Wisconsin Department of Transportation

Proposal #01: 1007-11-79, WISC 2018 433
Illinois State Line – Madison
E Church Rd to Church St-SB
IH 39
Dane County

1007-11-80, WISC 2018 434
Illinois State Line – Madison
Church Street to CTH AB-SB
IH 39
Dane County

This is Addendum No. 02, which provides for the following:

Addendum No. 02
ID 1007-11-79
Revised Sheet 37
November 1, 2018

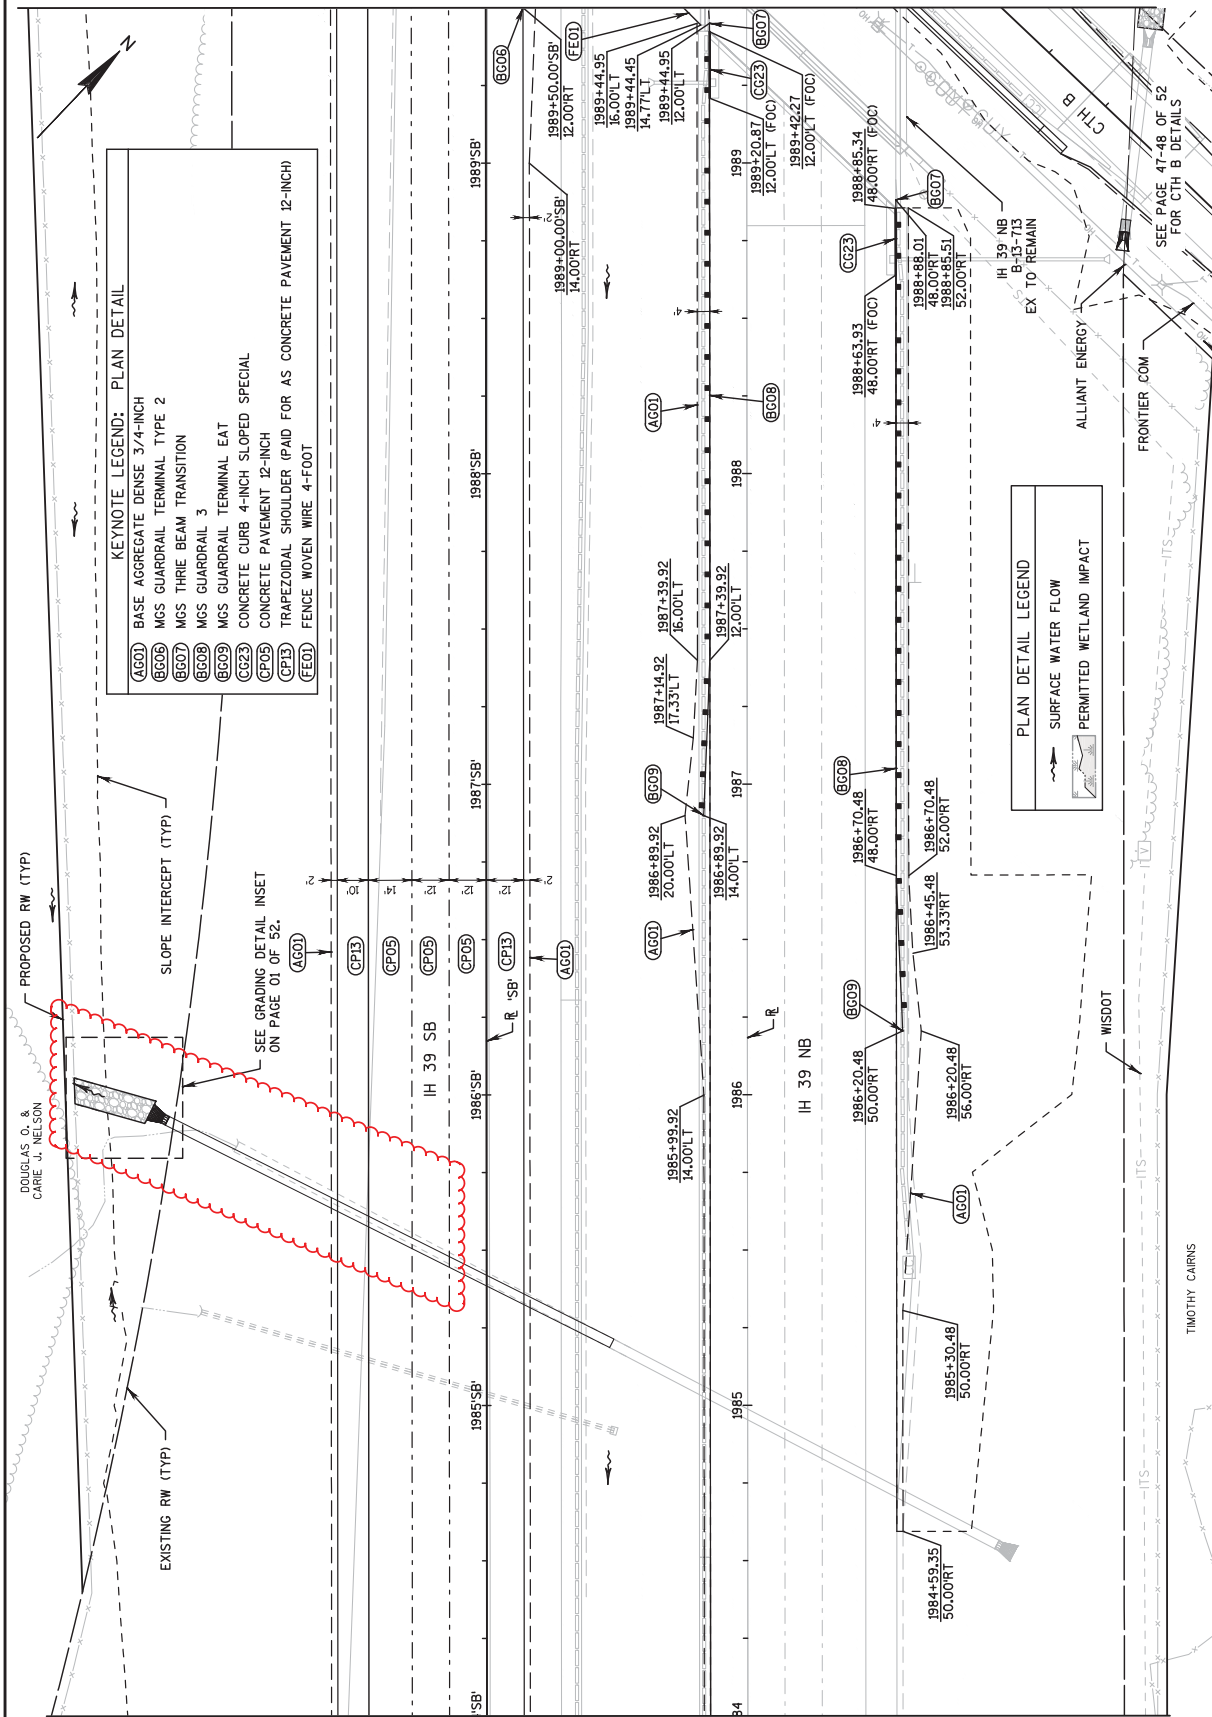
Revised Plan Sheets 1007-11-79	
Plan Sheet	Plan Sheet Title (brief description of changes to sheet)
37	Removal Plan (updated removals/abandoning culvert pipes)
53	Plan Detail (revised grading detail)
61	Plan Detail (revised pipe configuration/location)
106	Erosion Control (revised pipe configuration/location)
126	Planting Details (added note to compact salvaged topsoil and topsoil special)
128	Living Snow Fence and Seeding Details (revised dimensions, changed mulch to fabric)
155	Site B2: USH 51-STH 73 Plant Schedule (replaced table for clarity)
160	Site B5: Edgerton Road Plant Schedule (replaced table for clarity)
164	Site B3: Maple Grove Planting Schedule (replaced table for clarity)
170	Site B6: USH 51 Planting Schedule (replaced table for clarity)
174	Site B7: CTH A Plant Schedule (replaced table for clarity)
178	Site B9: CTH BN Plant Schedule (replaced table for clarity)
182	Site B10: Church Street Plant Schedule (replaced table for clarity)

LIVING SNOW FENCE
WEED FABRIC BARRIER
APPLICATION PLAN VIEW
N.T.S.

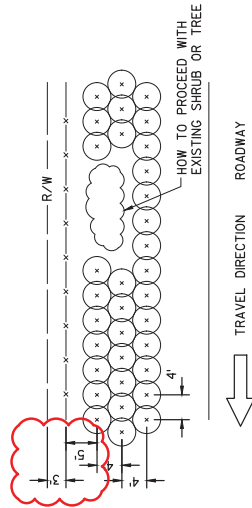
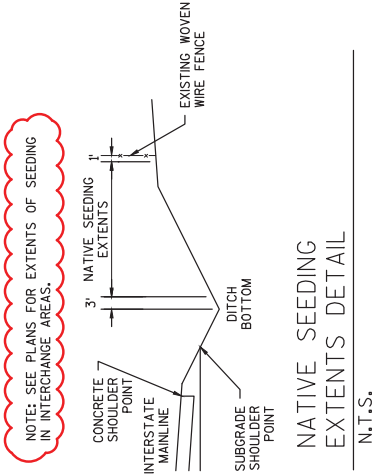
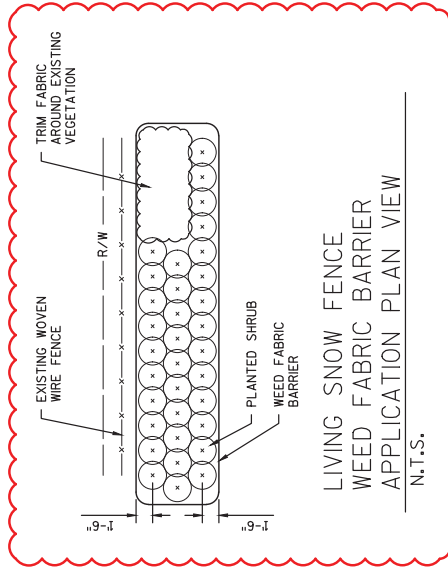
A geotextile weed barrier shall be placed around the living snow fence plants as shown in the plan detail.

Remove construction materials, stone, or other debris larger than 2" in length or diameter, debris, and trash from area receiving Weed Barrier Fabric. Lay the fabric flat on the smoothed soil and fit as close to the plants as possible. Provide a 4-inch overlap at adjoining sheets. Secure the fabric with T-shaped steel pin anchors sufficiently long to prevent the fabric from moving.

Addendum No. 02
ID 1007-11-79
Revised Sheet 280
November 1, 2018

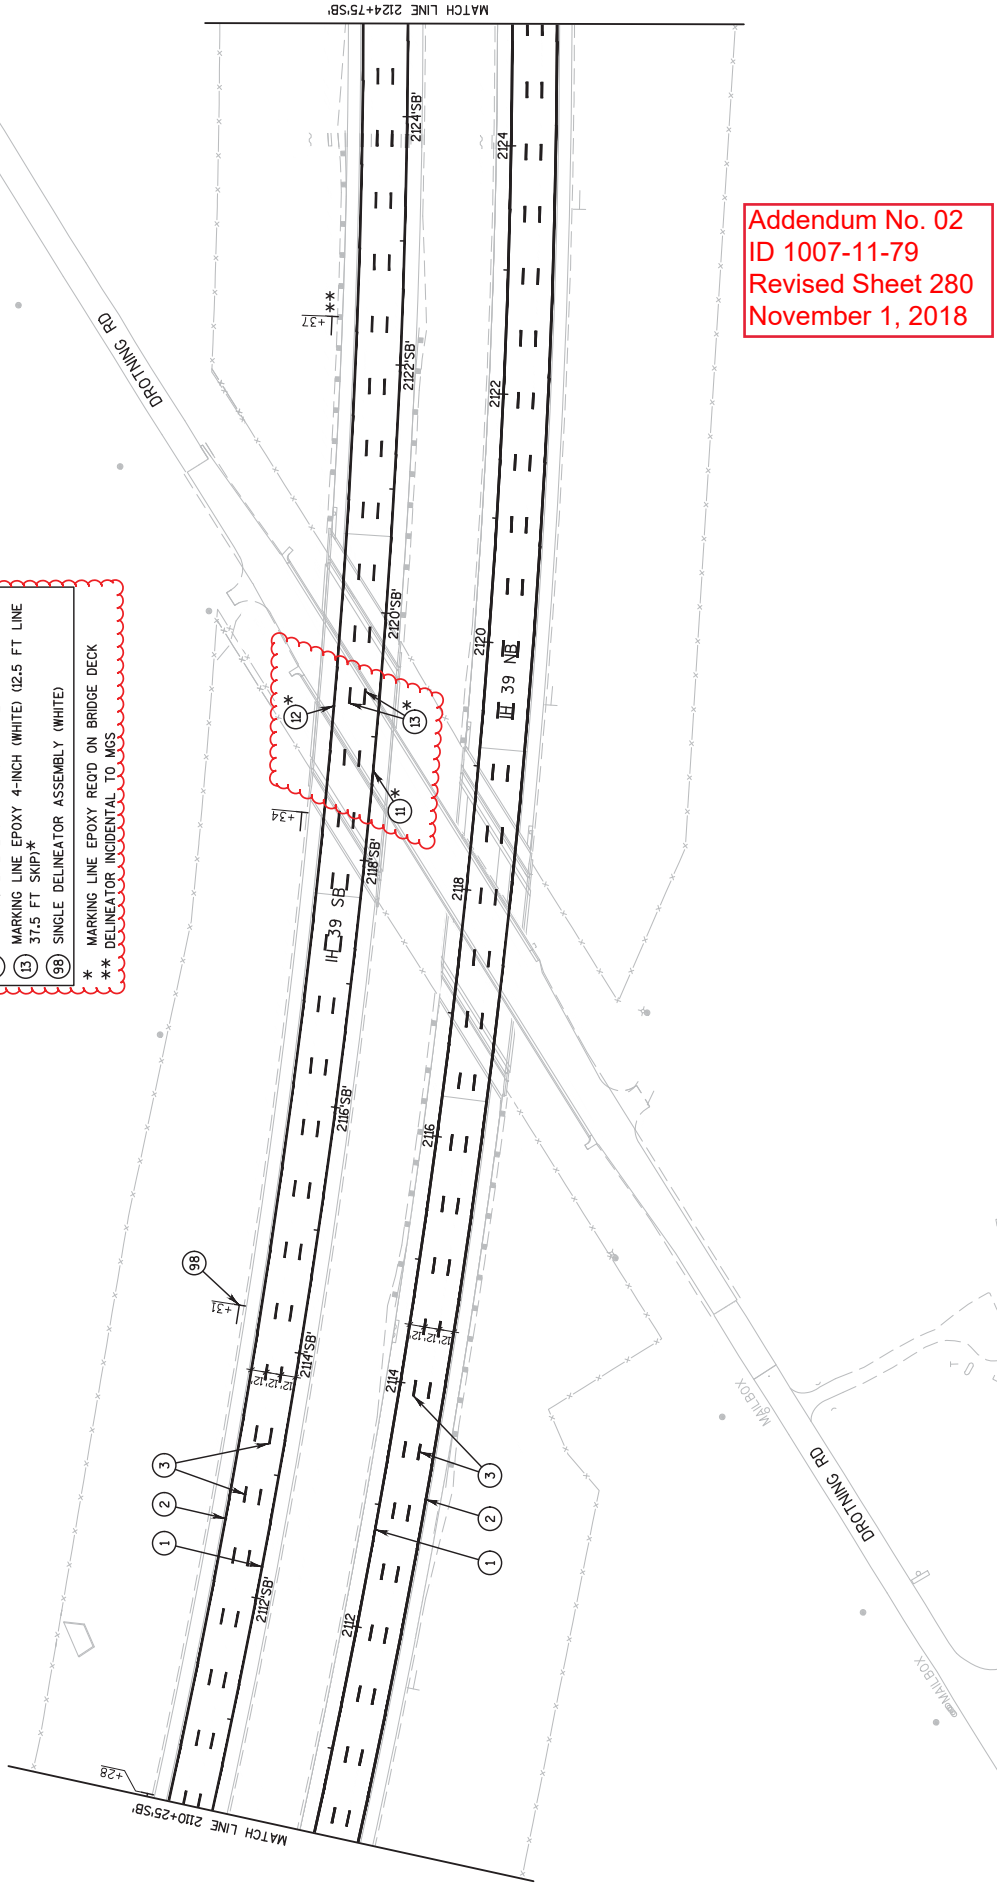
196	Site B12: CTH N Plant Schedule (replaced table for clarity)
204	Site B14: CTH AB Plant Schedule (replaced table for clarity)
272	Pavement Marking (added epoxy items on bridge deck)
280	Pavement Marking (added epoxy items on bridge deck)
367	Miscellaneous Quantities (revised item schedule)
372	Miscellaneous Quantities (revised item schedule)
375	Miscellaneous Quantities (added Topsoil and Shaping Shoulders items)
377	Miscellaneous Quantities (revised item schedule)
382	Miscellaneous Quantities-3 (added column for Weed Barrier Fabric)
422	Plan and Profile (revised pipe configuration/location)
574	Structure Plan (revisions to plan)
575	Structure Plan (revisions to plan)

Addendum No. 02
ID 1007-11-80
Revised Sheet 134
November 1, 2018

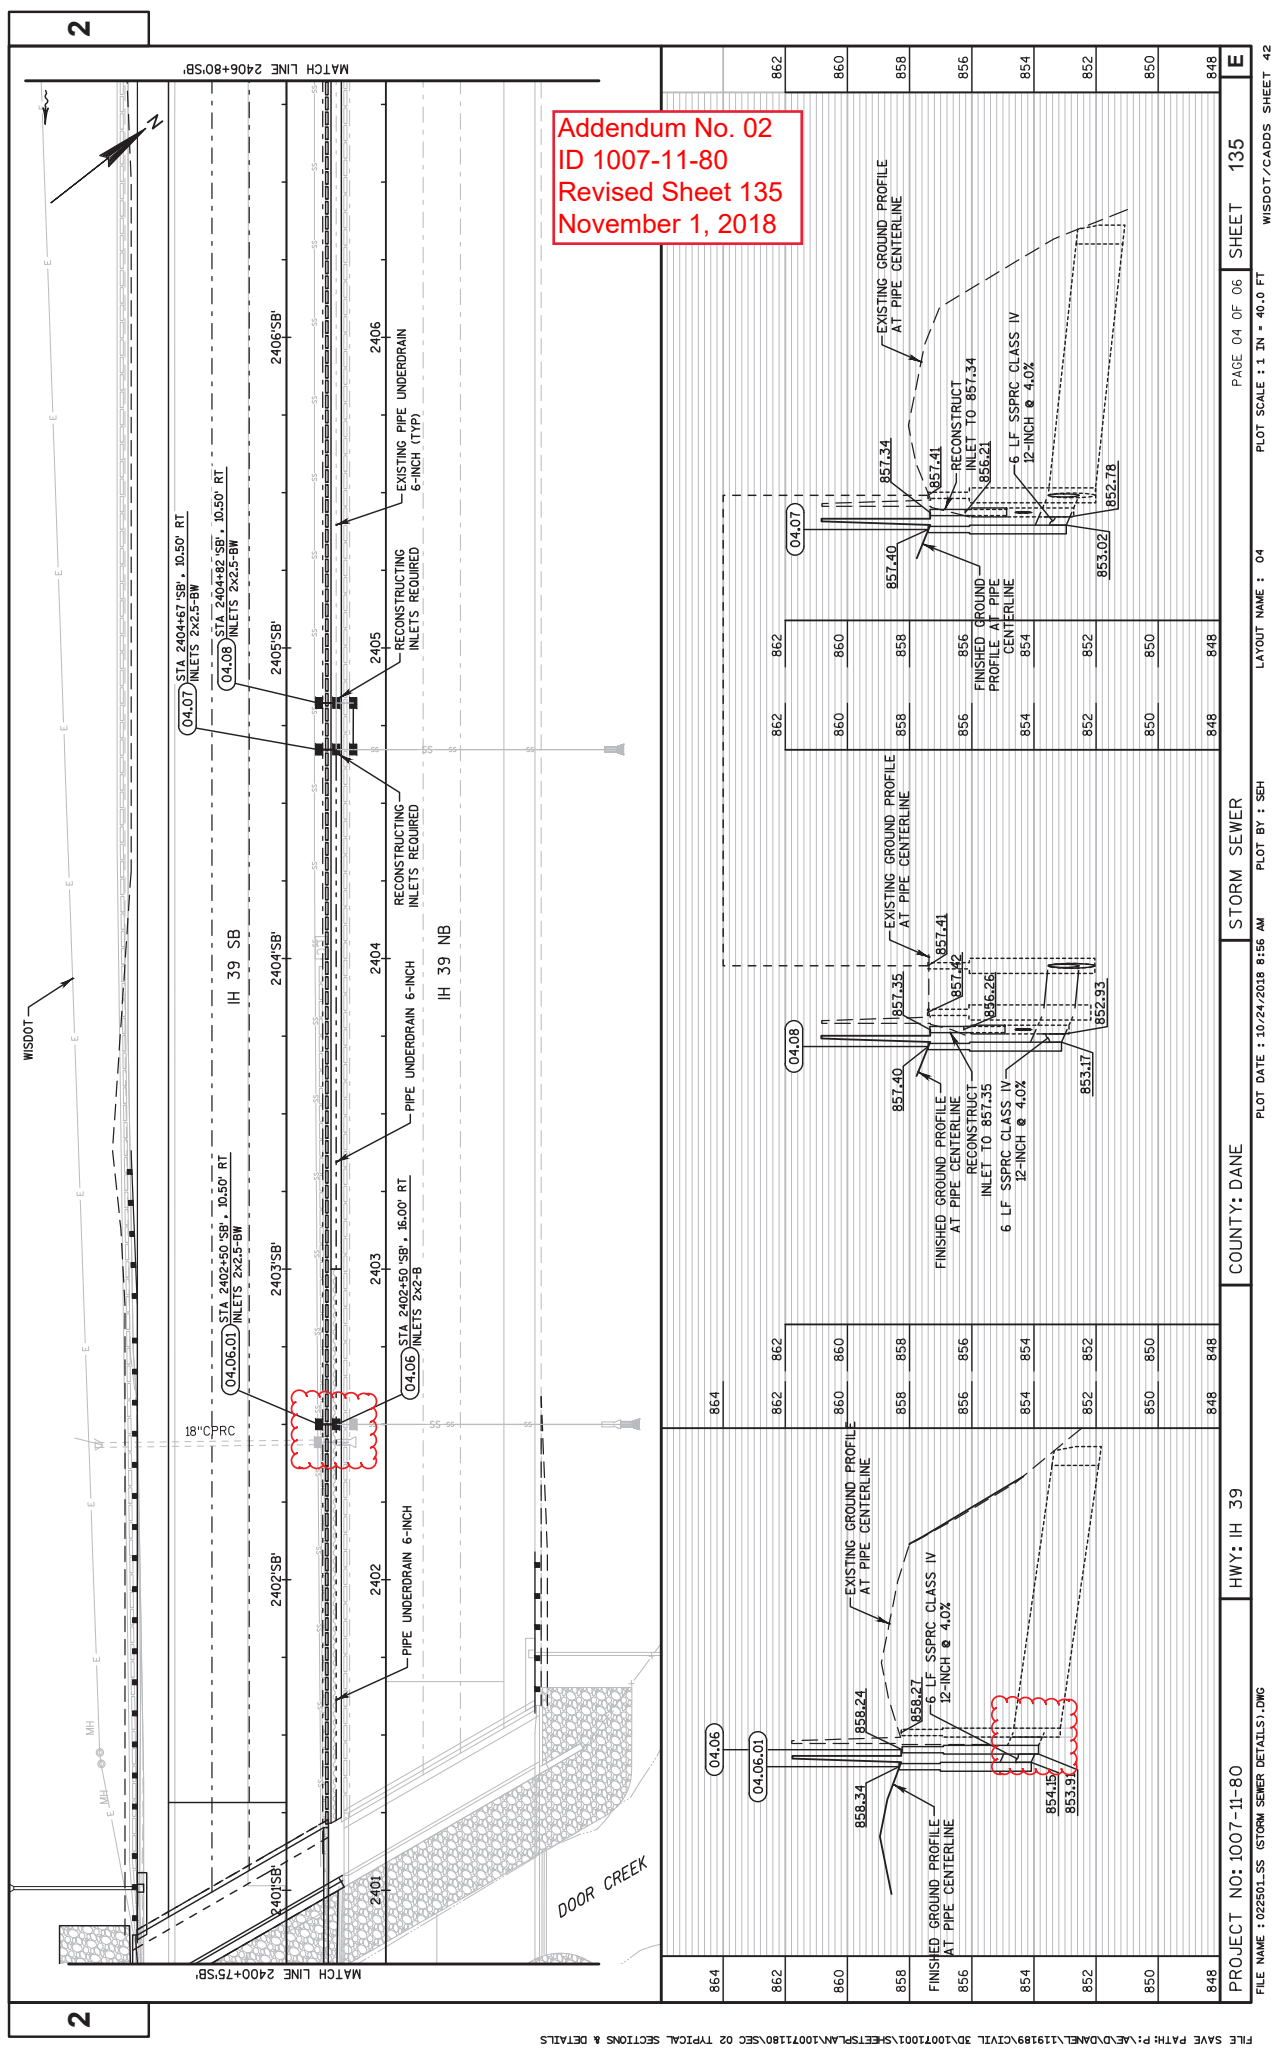
133	Storm Sewer (revised plan and profile views to show portion of pipe as existing – installed in previous contract)
134	Storm Sewer (revised plan and profile views to show portion of pipe as existing – installed in previous contract)
135	Storm Sewer (revised plan and profile views to show portion of pipe as existing – installed in previous contract)
177	Permanent Signing & Pavement Marking (revised to show SIS sign and existing sign removal)
180	Permanent Signing & Pavement Marking (revised to show SIS sign and existing sign removal)
190	Permanent Signing & Pavement Marking (revised markings on SB bridge)
267	Miscellaneous Quantities (revised item schedule)
268	Miscellaneous Quantities (revised item schedule)
273	Miscellaneous Quantities (revised item schedule)
275	Miscellaneous Quantities (revised item schedule)
278	Miscellaneous Quantities (revised item schedule)
521	Structure Plan (revisions to plan)
